C2M eye width

Piers Dawe, Nvidia

IEEE P802.3ck Task Force, October 2020 (r1)

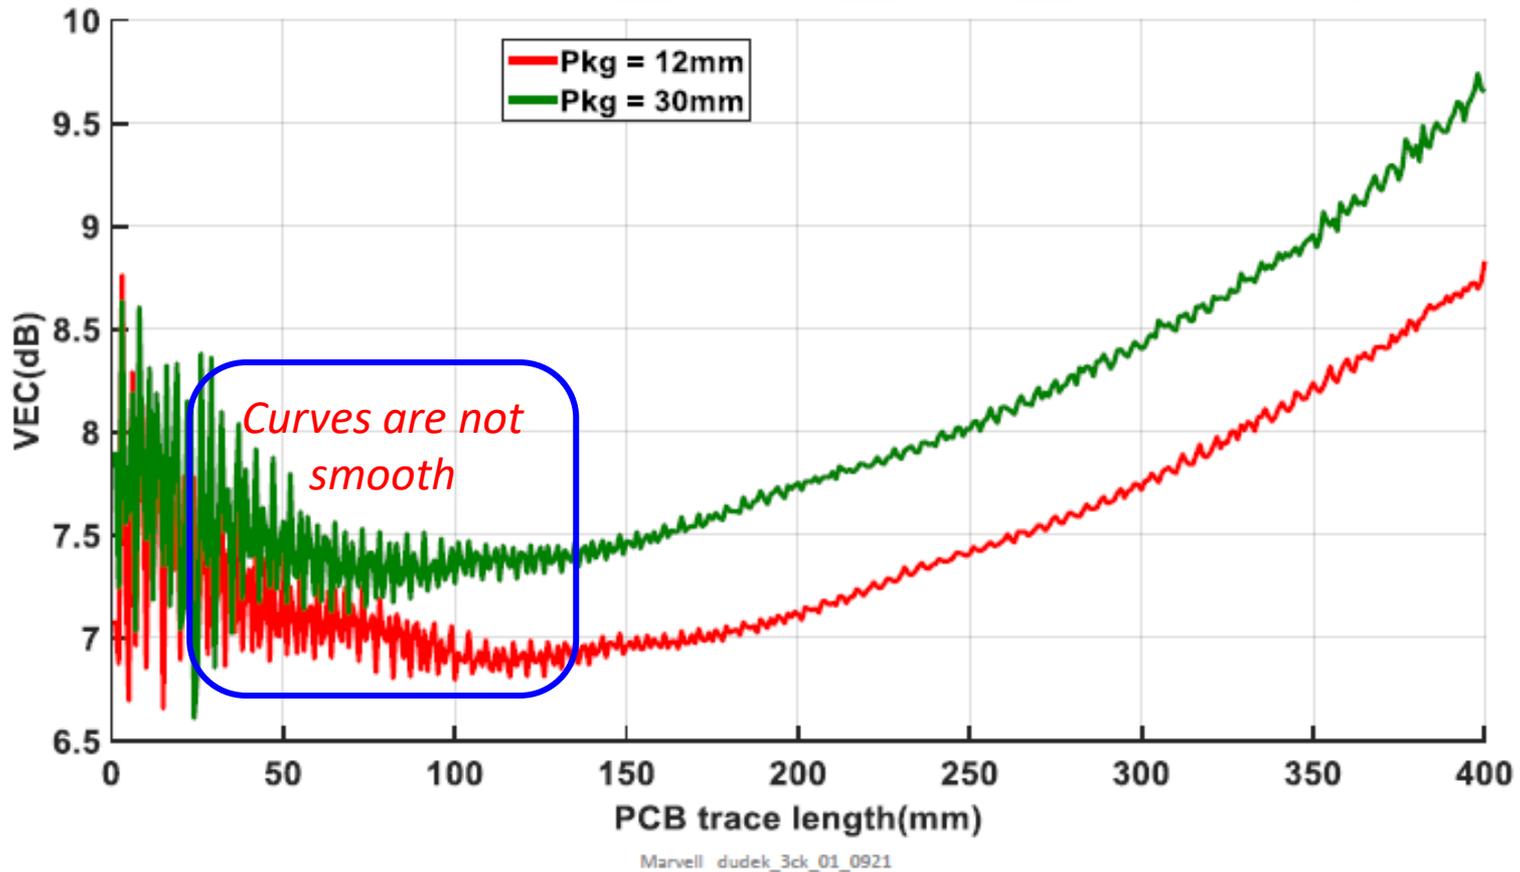
Dots appear in rows, which seem to be channel/package/driver sets

High loss on right (relatively high ESMW), low loss on left (relatively low ESMW)

As none of these is controlled by spec, what excludes other sets further to the left?

Faster package and driver are possible, have not been not explored? With a short channel, they will be to the left

Short channels were shown to be an issue (see next slide)

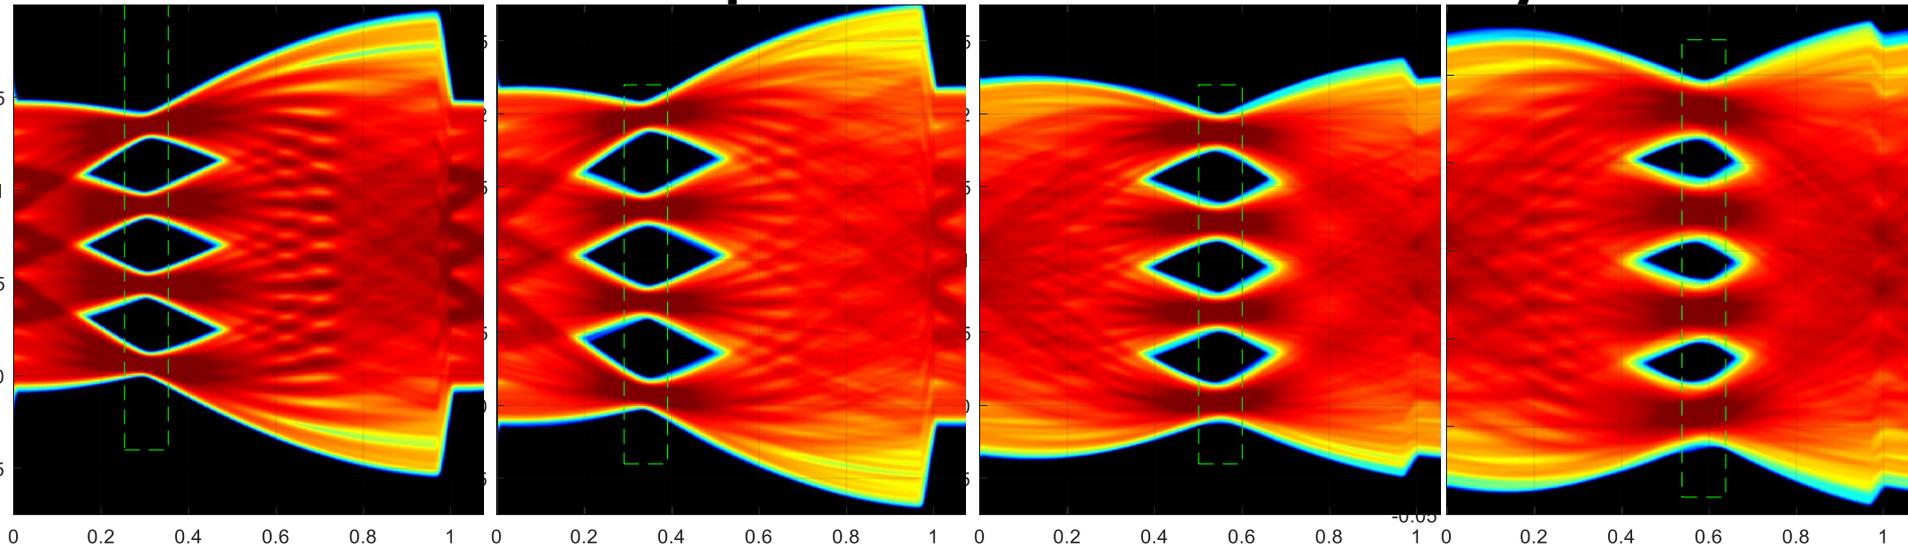
- This shows that small changes in reflection phase make big changes in VEC
- Eye width also changes, but not necessarily in proportion

VEC doesn't predict ESMW very well

- Eyes at TP1a are simulated with little noise and clutter for clarity, no module reflections. 31 mm COM package, 53.125 GBd. For each signal, VEC and width would vary in proportion depends on edge rate of that signal
- Steepest edges are late sides of eyes in right signals. For the same de-weighted VEC, this signal has worse ESMW
- Eye sides can be curved, further reducing ESMW
- Module output can do this too if not forbidden. Worse signals can exist (e.g. short package, worse reflections...)
